Modification	At what stage is this document in the process?
<p data-bbox="97 338 1134 409"><b>DCRP/MP/18/01/Report to Authority</b></p> <p data-bbox="97 490 1150 685"><b>Revision to Engineering Recommendation P28 “Voltage fluctuations and the connection of disturbing equipment to transmission systems and distribution networks in the United Kingdom”</b></p>	<div data-bbox="1177 331 1445 656"> <div data-bbox="1177 331 1445 405">01 Modification</div> <div data-bbox="1177 416 1445 490">02 DCRP report</div> <div data-bbox="1177 501 1445 575">03 Public Consultation</div> <div data-bbox="1177 586 1445 660">04 Final Modification Report</div> </div>
<p data-bbox="97 759 1426 936">The purpose of this document is to assist the Authority in its decision to implement the proposed modifications to the Distribution Code and Engineering Recommendation P28 (subsequently referred to as EREC P28). The proposed modifications were subject to industry consultation in January 2018. Responses from this consultation show that the industry is in favour of these modifications.</p> <p data-bbox="97 1003 639 1037"><b>Date of publication:</b> 25<sup>th</sup> February 2019</p>

<p data-bbox="97 1077 368 1111"><b

Figure 5 — Voltage characteristic for frequent events (Category 1)

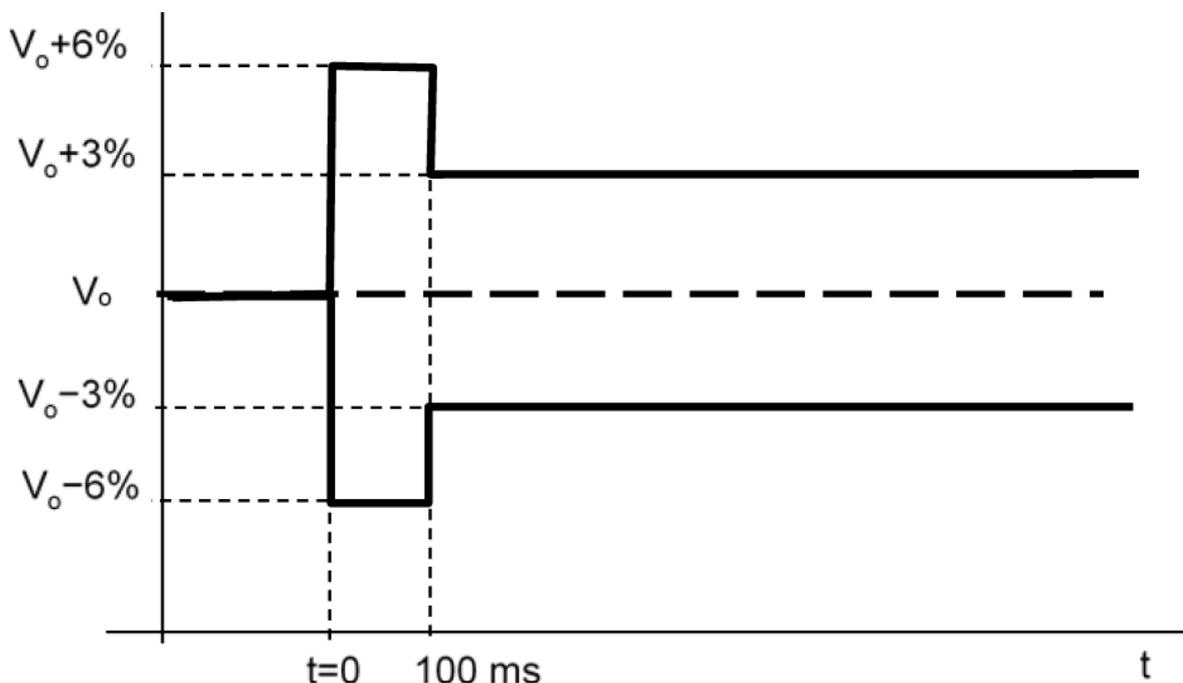
- Q1 Do you agree with the proposed requirements and planning levels for RVCs in EREC P28 Issue 2 (as provided in Figure 5, Figure 6, Figure 7 and Table 4 of EREC P28 Issue 2)?

- 5.6 However, two of the respondents provided extensive comments in relation to the proposed requirements and planning levels for RVCs as provided in Figure 5, Figure

6, Figure 7 and Table 4 of EREC P28 Issue 2 (see Question 1). The responses to Question 1 related to the following.

- a) The apparent setting of planning levels the same as operating levels for the higher categories of RVCs concerned one respondent because when the network is not operating correctly, equipment could be constrained off for long periods due to external events causing them to trip off.

- i) In response, the Working Group do not believe the requirements in EREC P28 Issue 2 are more onerous than Category 2 of Grid Code CC.6.1.7. The time and voltage magnitude limits for Category 3 RVCs shown in Figure CC.6.1.7 of the Grid Code when compared with Figure 7 of EREC P28 Issue 2 confirm that both the time and voltage limits in EREC P28 Issue 2 for Category 3 very infrequent events (not more than 4 RVCs in 1 day providing less frequent than once every 3 calendar months) are less onerous than those for Category 3 RVCs in the Grid Code.

6.4.1 The proposed changes to the RVC voltage envelopes arising from Figure 5, Figure 6 and Figure 7 of EREC P28 Issue 2 are expected to have a minimal impact on the NETS compared with those in CC.6.1.7 of the Grid Code. Under EREC P28 Issue 2 the maximum no. of occurrences of RVCs would change from typically 4 RVCs in one day (for commissioning, maintenance and fault restoration) typically not planned more than once per year on average over the lifetime of the connection to 4 RVCs in one day not more than once per three months. Whilst this increases the number of planned RVCs permitted per year these will be sufficiently spaced apart so as to minimise any potential disturbance to customers connected at PCCs. No impact is

- i) In response the Working Group believe there would be no realistic prospect of operation of the G59 undervoltage stage 1 protection for external RVC events that conform with the limits and requirements of EREC P28 Issue 2. Furthermore, the reference to "Commissioning, maintenance and post fault switching" in Table 4 of EREC P28 Issue 2 is an example of applicability. NOTE 7 in Table 4 states that these are examples only and that customers may opt to conform to the limits of another category providing the expected frequency of the events do not exceed the maximum frequency permitted for the chosen category. Commissioning, maintenance or post fault switching activities could be classed as Category 1, Category 2 or Category 3 events depending upon the maximum number of occurrences foreseen for those events.

- a. Subsequent to their initial response the Working Group would point out that Table 4 of EREC P28 Issue 2 refers to planning levels for RVCs, which should be used for design and planning of connections. Whilst design pre-connection should be based on an expected number of both planned and unplanned RVCs over specified time periods to comply with Table 4, it is recognised that Users do not have control of the number of actual unplanned RVC events, including G59 trips, that could occur post connection.

- iii) In their response, the Working Group pointed out that the limits in Table 4 of EREC P28 Issue 2 and the associated amendments to the Distribution Code have been carefully chosen to allow a greater number and magnitude of RVC type voltage fluctuations than is currently permitted whilst not posing an unacceptable risk of voltage complaints from other customers connected to the system. It would not be acceptable to increase the RVC limits proposed for Category 2 and Category 3 events in EREC P28 Issue 2 simply to avoid the need for disturbing equipment connectees to mitigate unacceptable voltage fluctuations caused by the energisation of their equipment, where these fluctuations could cause an unacceptable risk of interference to other customers.

Figure 6 — Voltage characteristic for infrequent events (Category 2)

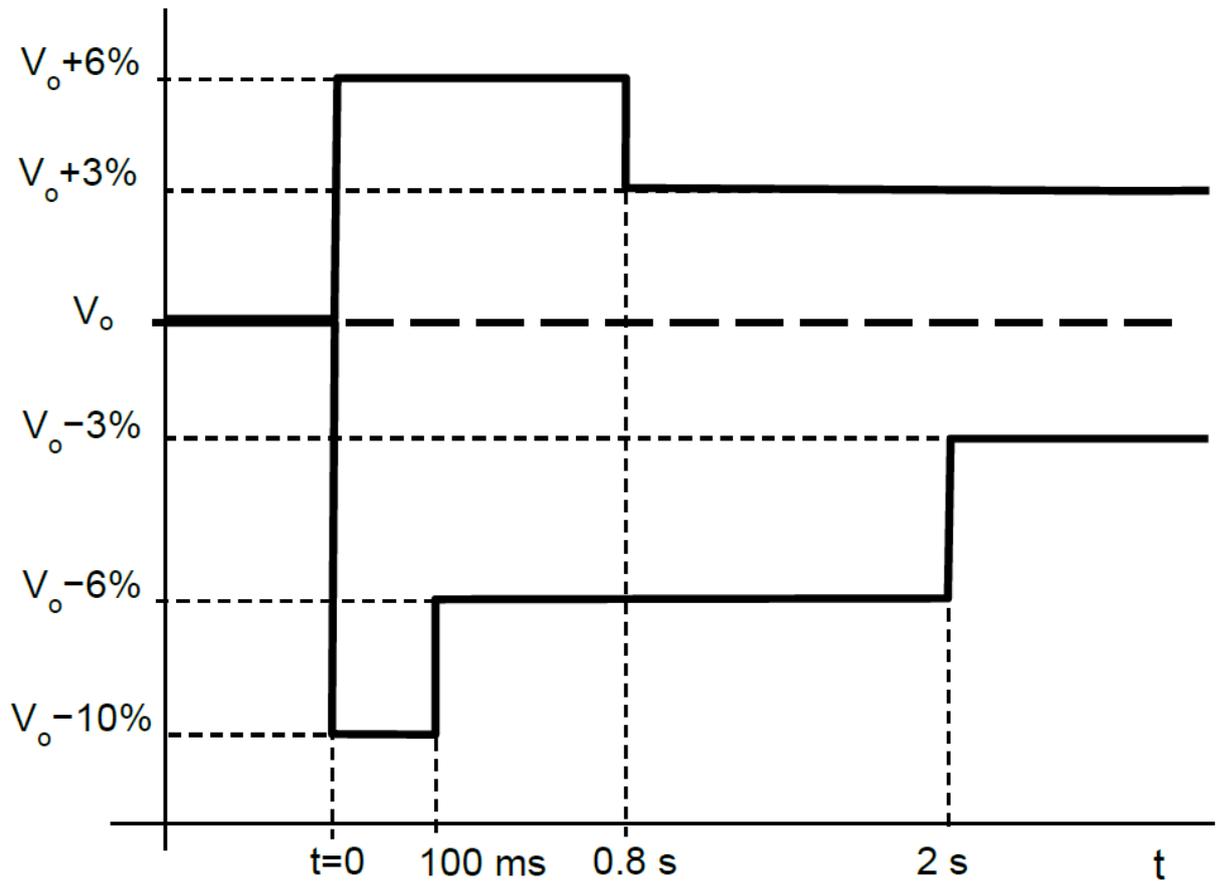
4.2.12 Up to 4 RVC events per calendar month are permitted for voltage fluctuations fitting within the envelope in Figure 6.
